Project Number: 1474

**Subject: Barrhaven Conservancy West - Hydraulic Impact Assessment**

This Memo is related to the Barrhaven Conservancy West lands and specifically addresses comments received as part of the Barrhaven Conservancy West Draft Plan circulation, notably, comments 4.5 and 4.6 prepared by the RVCA.

Figure 2: Conveyance Overview

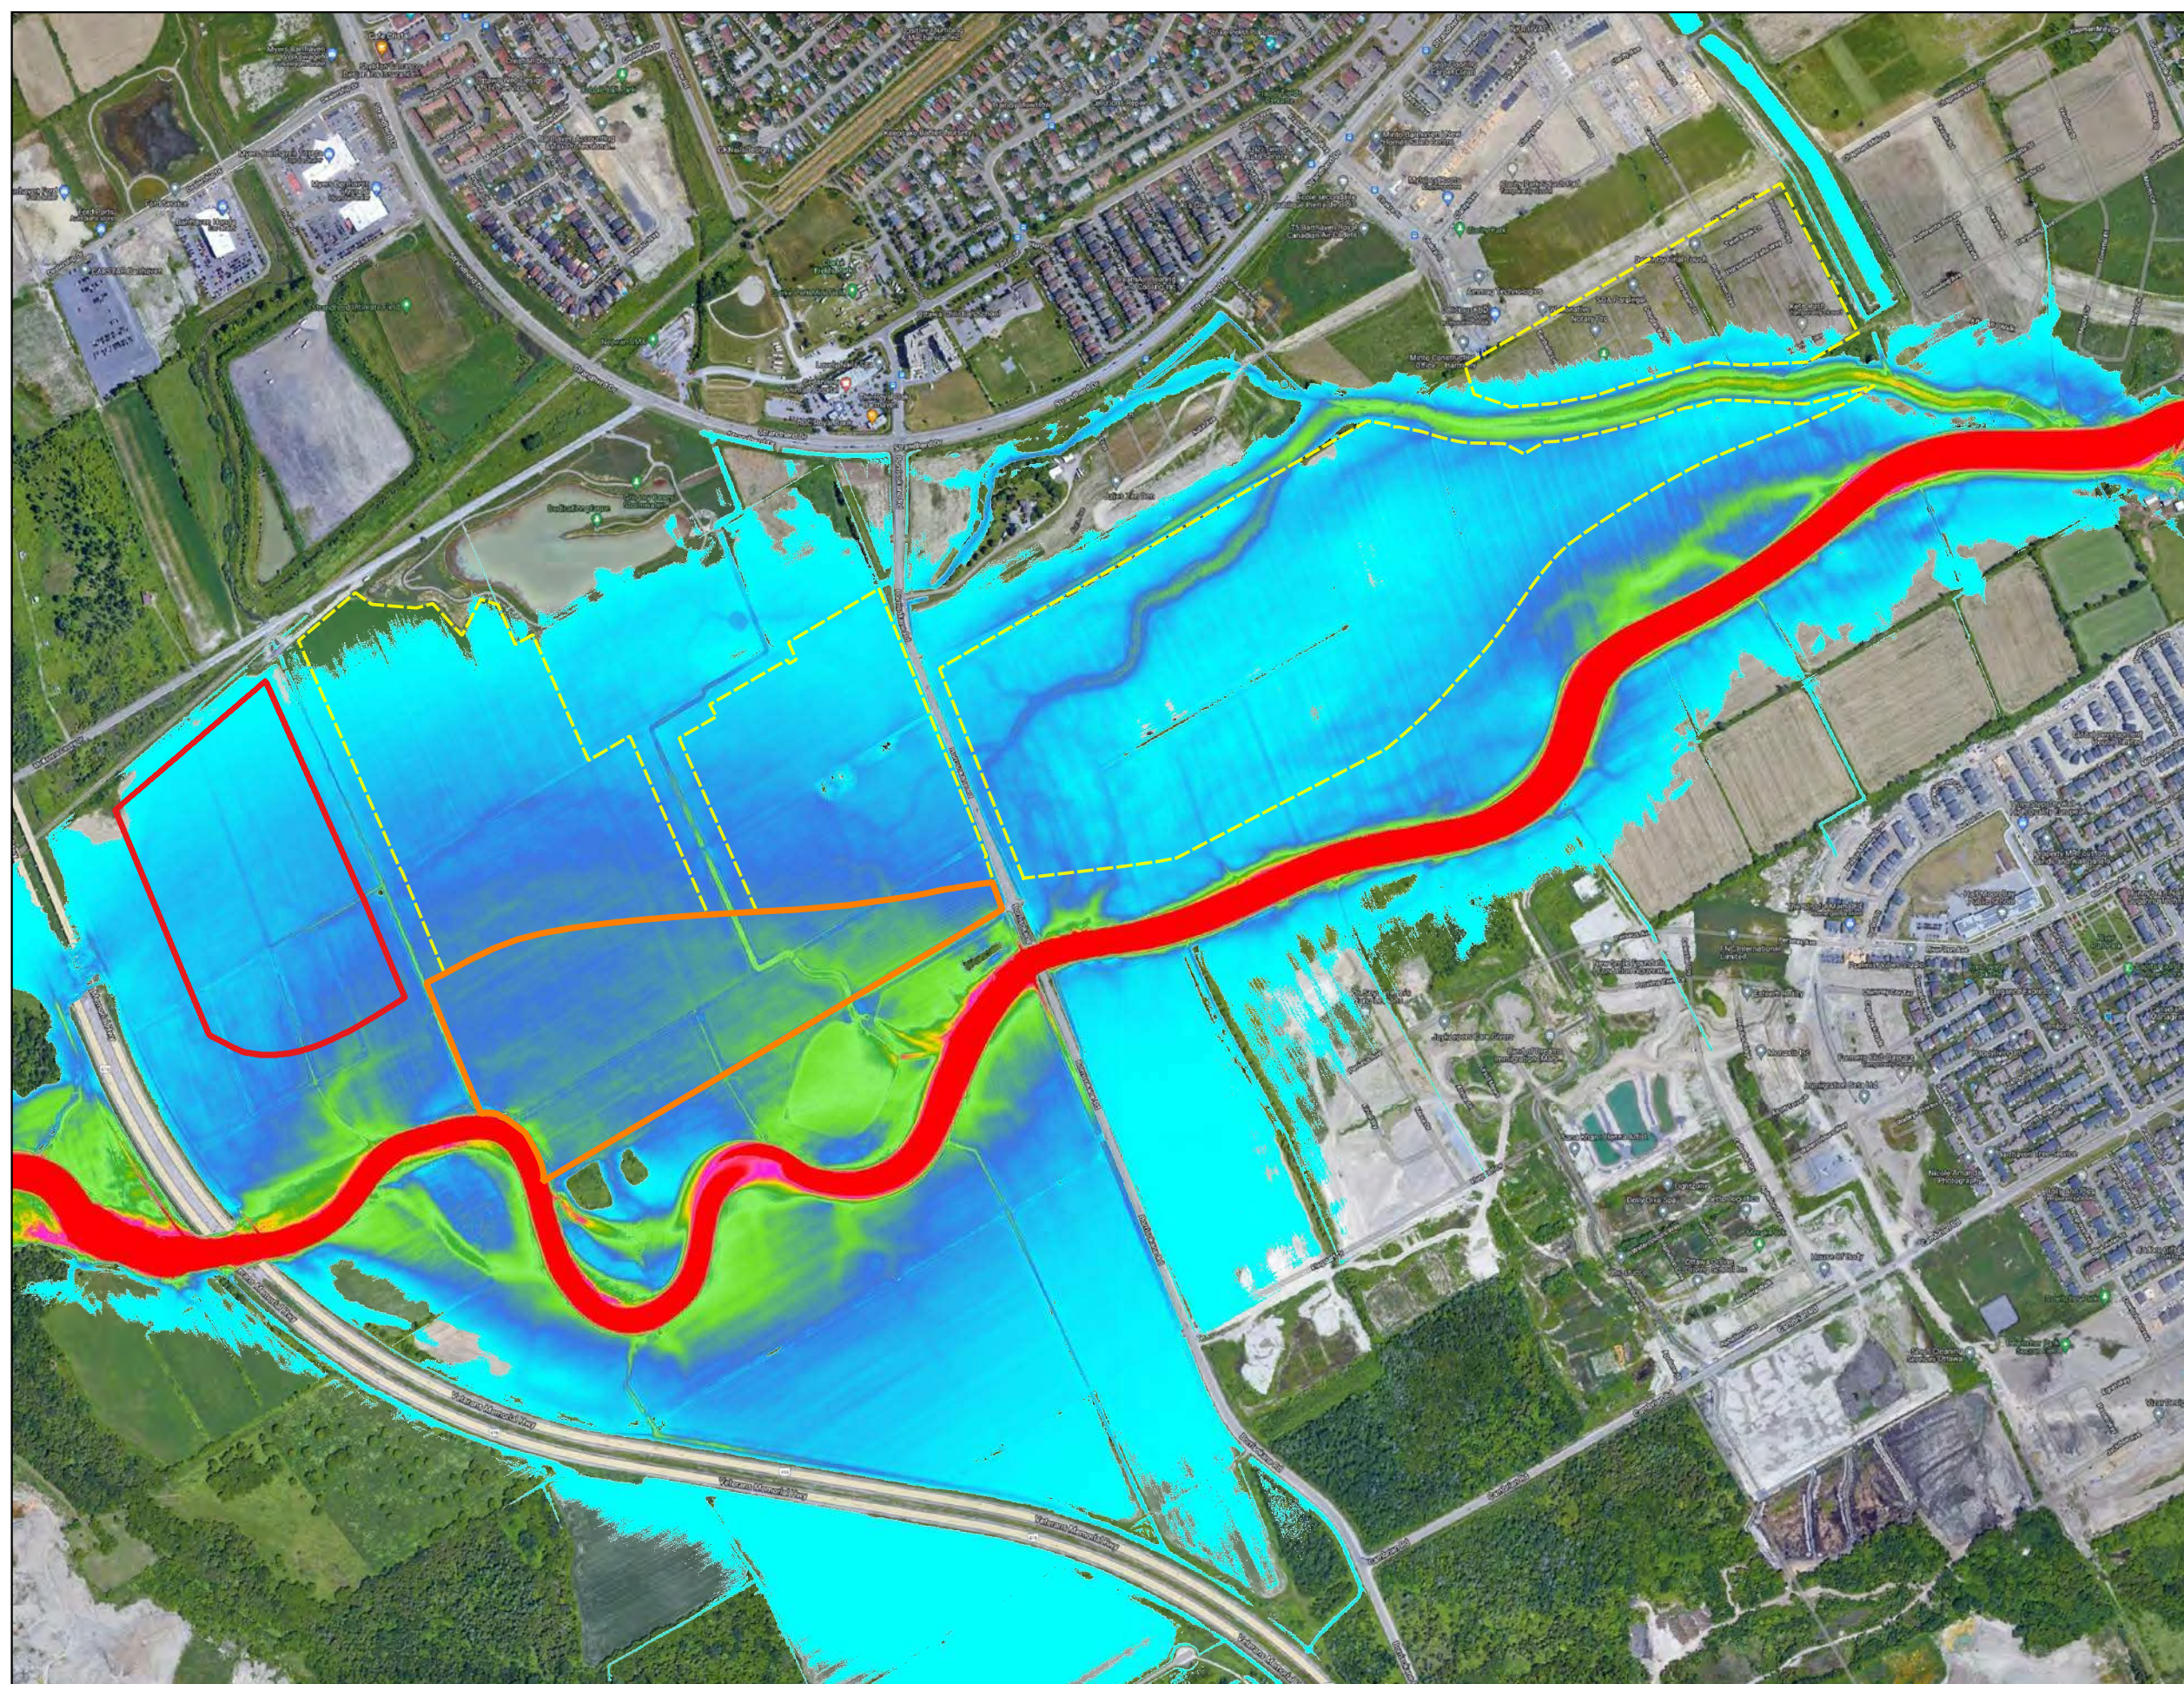
*4.5. Further, as part of the RVCA letter of permission (RV5-4419) for flood plain modifications, a monitoring program has been initiated as a condition of approval. As part of the monitoring program, it has been anticipated by the Conservation Authority that portions of the proposed subdivision are to be held from development as a potential area for modification should the monitoring program identify a need for additional cut be required. Portions of the lands west of the current O'Keefe alignment were identified as being the optimal location to provide additional cut should it be required. As such, development of these lands should be held in abeyance, until the monitoring program has been completed and that an additional cut is demonstrated to not be required. [emphasis added]*

Alternatively, optimizing how the flows are conveyed through this section of the watercourse can have significant benefits in mitigating peak water levels during extreme events. As outlined above, given the size of this watercourse, improving flow conveyance is a far more effective tool for mitigating peak flood elevations than providing additional flood plain storage volume. **Figure 2** is an excerpt from the JFSA 2019 report [with additional annotations provided for context for this memo] which in essence is a “flow heatmap” under pre-development conditions (Circa 2019). This figure graphically indicates where the majority of the flow during the 100-Year event is located within the greater flood plain area.

As expected, the majority of the flow during the 100-year event is within the channel. Outside of the main channel, there appears green and dark blue shading indicating the major conveyance path when flows are over bank. As seen from this figure, the majority of the lands proposed by the RVCA to be held in abeyance are outside of this conveyance path and primarily contained within the light blue low-flow area. This demonstrates that cutting these lands will not have a significant impact on flow conveyance and, similarly, peak water levels on the Jock River, since the majority of the flows are elsewhere within the floodplain. It is important to emphasize that the approved development boundaries west of Borrisokane Road were specifically located, by design, to avoid impact on the conveyance pathway of the Jock River floodplain. This is why the development boundaries of these three parcels along the southern edge approximately reflect the shape and limit of the conveyance path identified above.
